Addendum Cover Page

2. Addendum to (Title): Multiscale Thermohydrologic Model			
3. ID (including Revision and Addendum No.): ANL-EBS-MD-000049 REV03 AD 02			
	Printed Name	Signature	Date
4. Originator	Thomas A. Buscheck	<i>Thomas A. Buscheck</i>	1/29/08
5. Independent Technical Reviewer	Sunil Mukhopadhyay	<i>Sunil Mukhopadhyay</i>	1/29/2008
6. Checker	Scott James	<i>Scott James</i>	1/29/08
6. QCS / QA Reviewer	Charles Beach	<i>Charles P. Beach</i>	1-29-08
7. Responsible Manager / Lead	Ernest Hardin	<i>Ernest Hardin</i>	1/29/08
8. Responsible Manager	M. Kathryn Knowles	<i>M. Kathryn Knowles</i>	1/29/08
9. Remarks			
Change History			
10. Revision and Addendum No.	11. Description of Change		
REV 03 AD 02	Initial Issue. Changes in response to DOE comments and for TBV resolution.

SUMMARY AND ORGANIZATION

Figure 6.3-77[b]. CCDF for (a) Peak Drift Wall Temperature and (b) Peak Waste Package Temperature for the Range of Parametric Uncertainty Addressed by the MSTHM

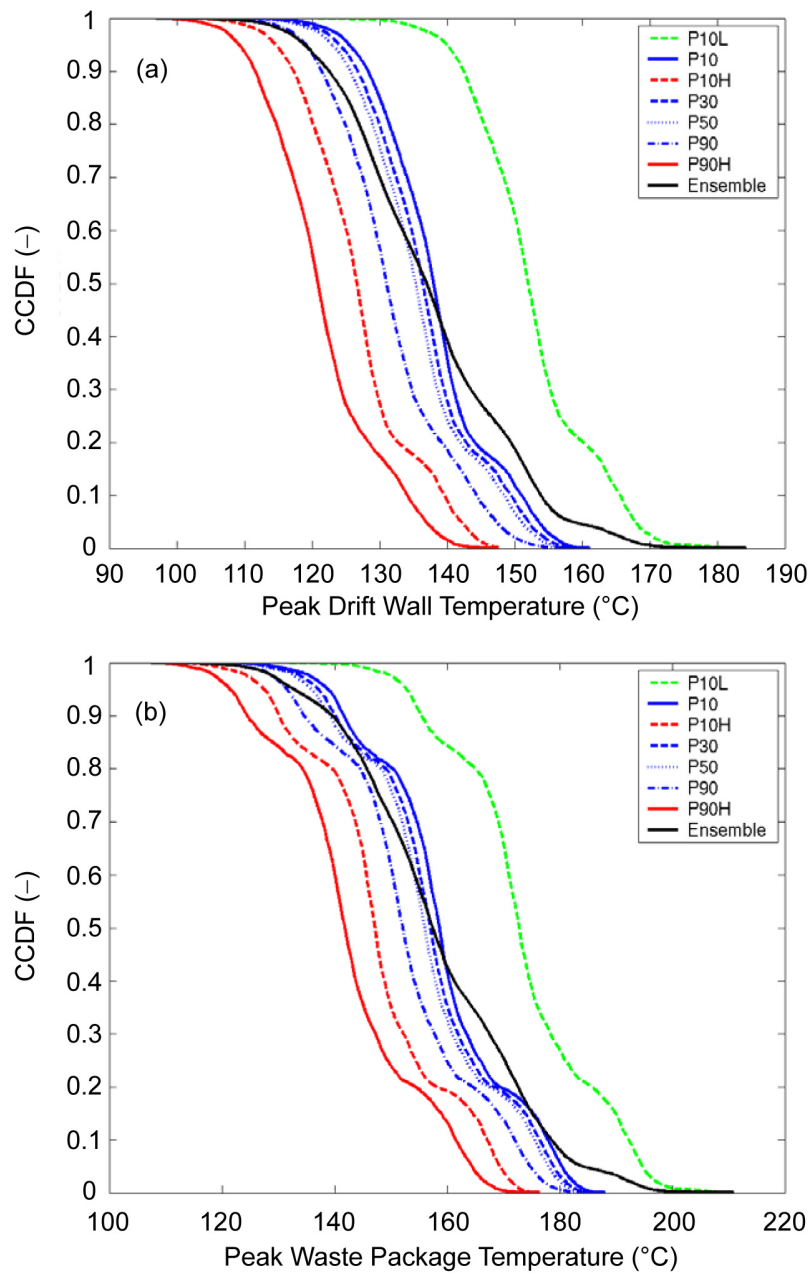
[Two figures and two tables are slightly revised from those in the parent report. The small revisions result from the implementation of the weighting factors from the unit cell in Table 6.2-6[a] of the parent report. The unit cell has eight waste packages, two half waste packages and six full waste packages. The CCDF plots in Figures 6.3-77[a] and 6.3-77[a] of the parent report apply equal weights to the eight waste packages. The revised figures (Figures 6.3-77[b] and 6.3-78[b]) apply a weighting factor of 0.5 to the two half waste packages and a weighting factor of 1.0 to the six full waste packages. This change resulted in very minor changes to these figures. Note that these figures are included in the report for illustration purposes only. The other minor change to these figures involves the implementation of the weights in Table 6.3-48[a] of the parent report to produce the ensemble plot. The original ensemble plots were produced using equal weights for the seven host-rock thermal conductivity/percolation flux cases. Tables 6.3-49[a] and 6.3-50[a] of the parent report are revised to be consistent with the revisions to the figures discussed above.]

[The following replaces Figure 6.3-77[a] on page 6-39[a] of the parent report. The revised figure weights the respective waste package locations according to Table 6.2-6[a] of the parent report and implements the weights from Table 6.3-48[a] of the parent report for the ensemble.]

NOTE: Each of the seven CCDF plots represents 26,112 values, which is the product of eight different waste packages at 3,264 locations across the repository. These are the maximum temperatures corresponding to the 182,784 temperature histories in Figure 6.3-76[a] of the parent report. The ensemble is based on the data from the seven cases, using the weights from Table 6.3-48[a] of the parent report.

Figure 6.3-78[b]. CCDF for the Time When Boiling Ceases on the (a) Drift Wall and (b) Waste Package for the Range of Parametric Uncertainty Addressed by the MSTHM

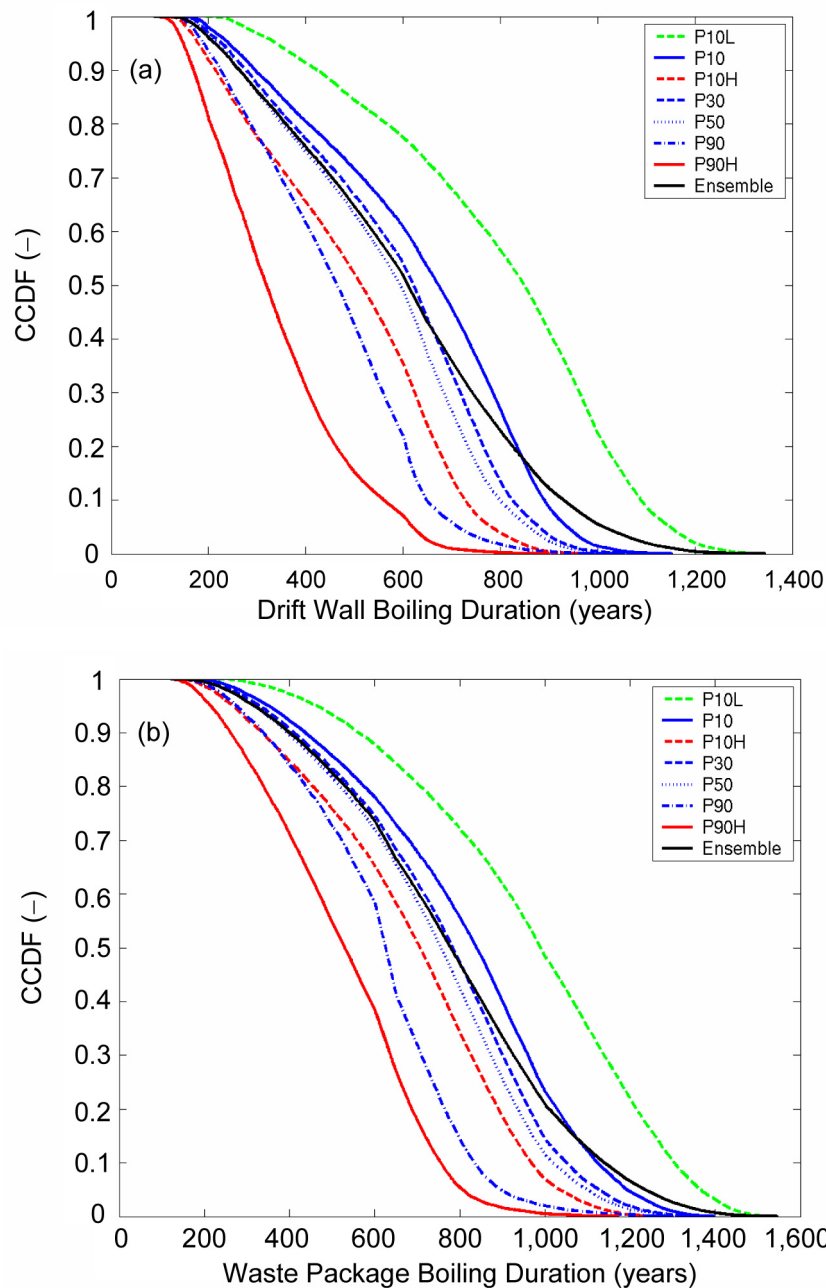
[The following replaces Figure 6.3-78[a] on page 6-40[a] of the parent report. The revised figure weights the respective waste package locations according to Table 6.2-6[a] of the parent report and implements the weights from Table 6.3-48[a] of the parent report for the ensemble.]

NOTE: Each of the seven CCDF plots represents 26,112 values, which is the product of eight different waste packages at 3,264 locations across the repository. These are the times when boiling ceases corresponding to the 182,784 temperature histories in Figure 6.3-76[a] of the parent report. The ensemble is based on the data from the seven cases, using the weights from Table 6.3-48[a] of the parent report.
